REGULATORY INFORMATION DISTRIBUTION SYSTEM

Subject: WPPSS NUCLEAR PROJECT NO. 2
RESPONSES TO CONTAINMENT SYSTEMS BRANCH,
CORE PERFORMANCE BRANCH, AND GEOSCIENCES
BRANCH QUESTIONS

Docket No. 50-397 Responses to Containment
Systems Branch, Core Performance Branch, and
Geosciences Branch Questions

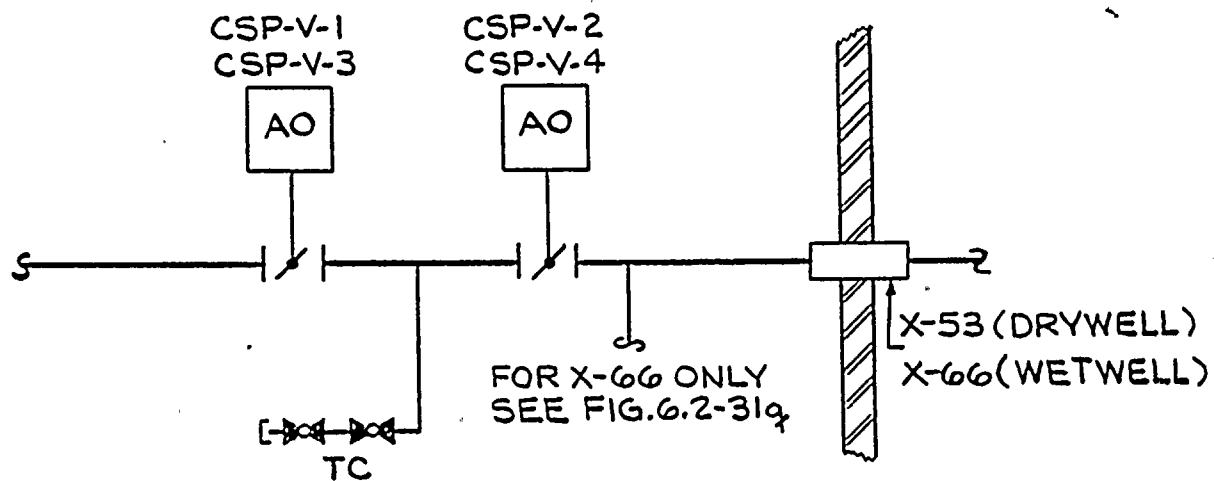
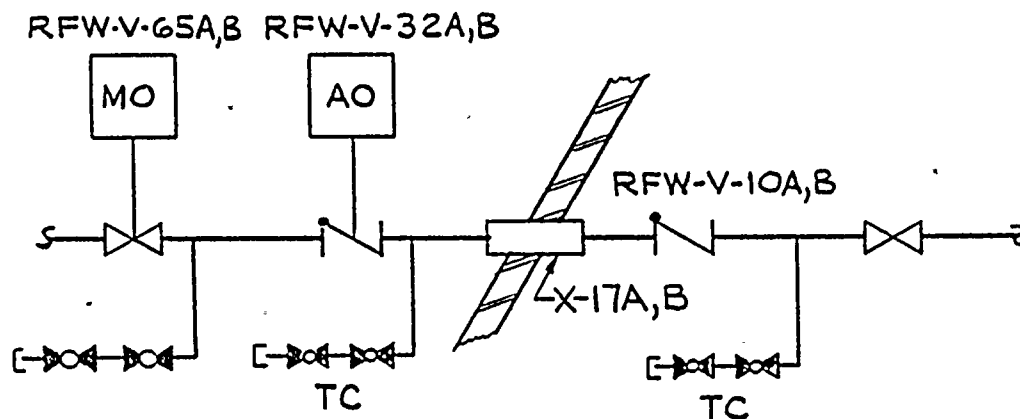
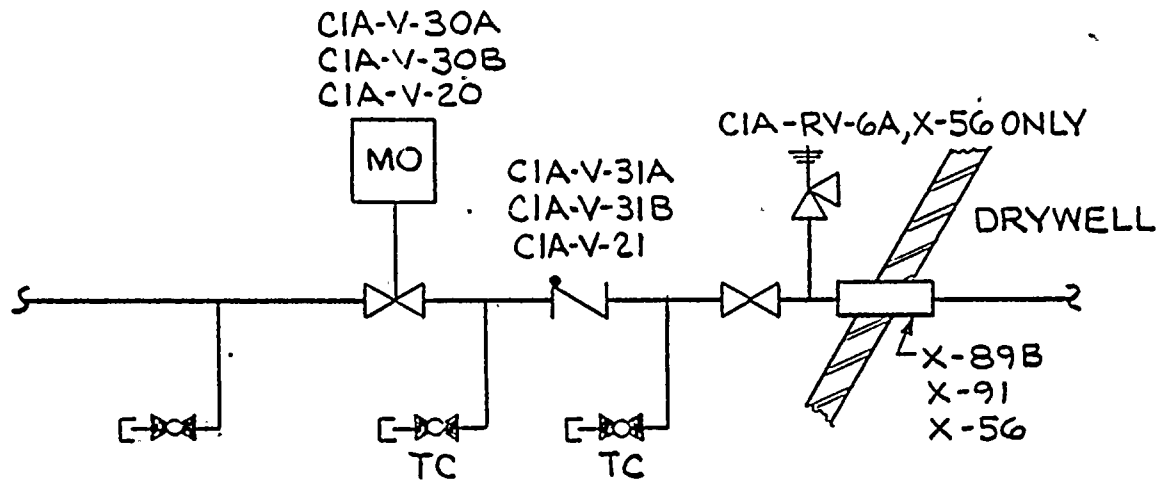
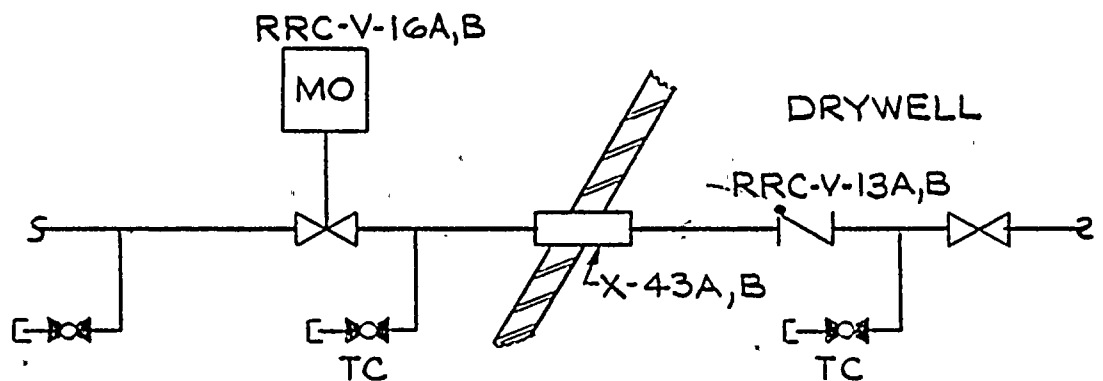
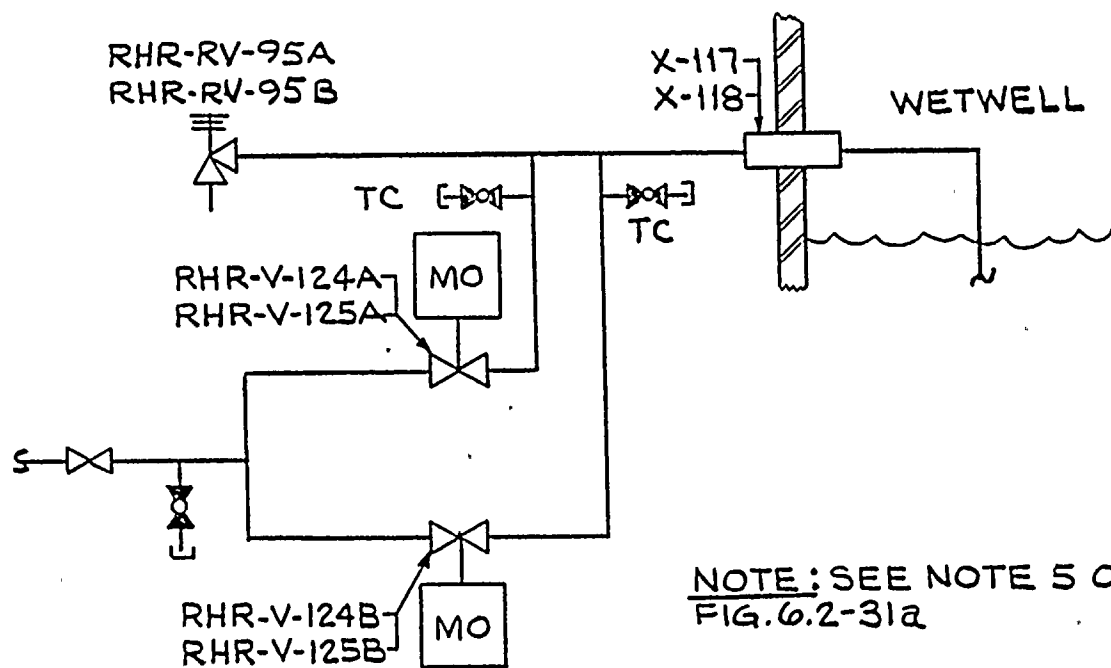
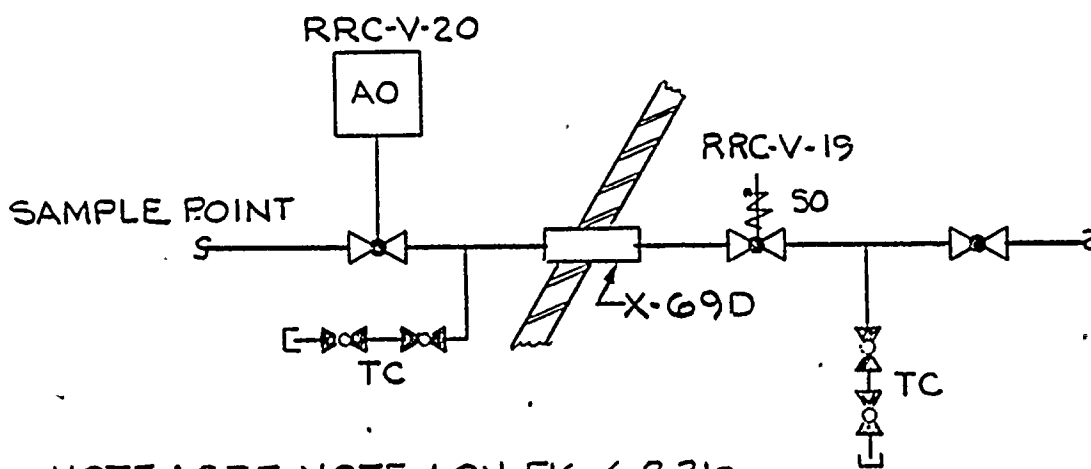
Provide the following information with regard to the leakage rate testing of the Type C containment isolation valve (as defined in Appendix J to 10CFR Part 50):

- a. For each fluid line that penetrates the containment, show schematically the isolation valve arrangement and the design provisions that will permit the isolation valves to be leak tested. Indicate the direction in which the valves will be leak tested.
- b. Identify the containment isolation valves that will not be subjected to Type C leak testing, and provide justification for not leak testing these valves.

- a. All fluid lines which penetrate the primary containment and the associated containment isolation valves which will be subject to Type C testing are illustrated in Figure 6.2-31(a-t). These figures also indicate how the Type C tests will be conducted.
- b. The only lines which have not been identified as subject to Type C testing are:
 1. All instrument lines (TABLE 6.2-16, NOTE 27)*
 2. CRD insert and withdrawal lines (TABLE 6.2-16, NOTE 4)*
 3. TIP lines (TABLE 6.2-16, NOTE 29)*
 4. RRC hydraulic control lines (TABLE 6.2-16, NOTE 28)*

*TABLE 6.2-16 NOTES REFERENCED PROVIDE THE JUSTIFICATION FOR NOT TYPE C LEAK TESTING.
(SEE QUESTION 22.027 FOR REVISED TABLE 6.2-16)

FIGURE
6.2-17

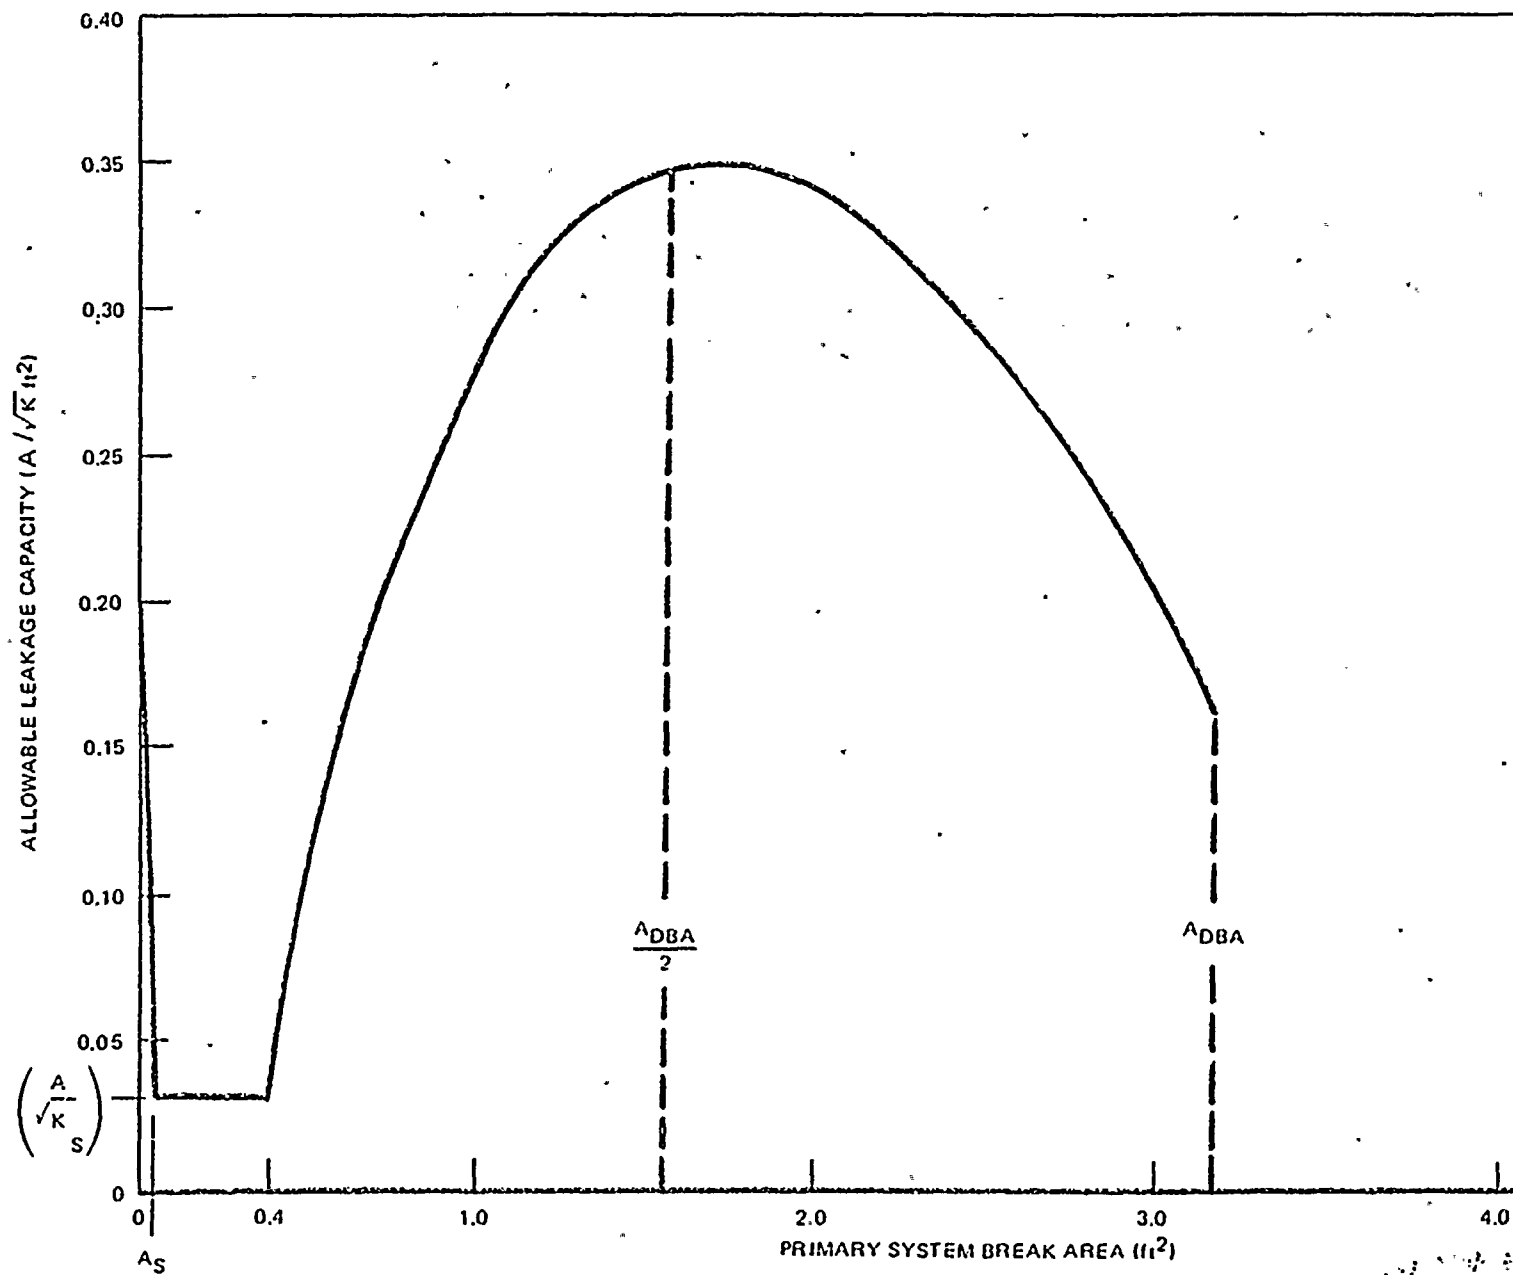
It is the staff's position that insufficient time is available for the operator to reliably take the manual actions which are necessary to initiate suppression pool spray during a small break. The staff has established the requirement for automatic initiation of suppression pool spray for the Mark II containment. Accordingly, we require you to provide a Class IE automatic control system for each suppression pool spray system.

The containment has been analyzed to determine the allowable leakage between the drywell and suppression chamber. Figure 6.2-17a shows the allowable leakage capacity (A/\sqrt{K}) as a function of primary system break area. A is the area of the leakage flow path and K is the total geometric loss coefficient associated with the leakage flow path.

Figure 6.2-17a is a composite of two curves. If the break area is greater than approximately 0.4 square feet, natural reactor depressurization will rapidly terminate the transient. For break areas less than 0.4 square feet, however, continued reactor blowdown limits the allowable leakage to small values. The maximum allowable leakage capacity is at $A/\sqrt{K} = .026$ square feet. Since a typical geometric loss factor would be three or greater, the maximum allowable flow path would be about .052 square feet. This corresponds to a 3 inch line size.

The allowable bypass leakage of 0.028 ft² is well above the maximum possible containment bypass leakage. Periodic testing will be performed to confirm that the containment bypass leakage does not exceed $A/\sqrt{K} = 0.0045$ ft². Figure 6.2-17c presents the resulting containment transient for $A/\sqrt{K} = 0.0045$ ft². The peak containment pressure shown in Figure 6.2-17c is well below the containment design pressure.
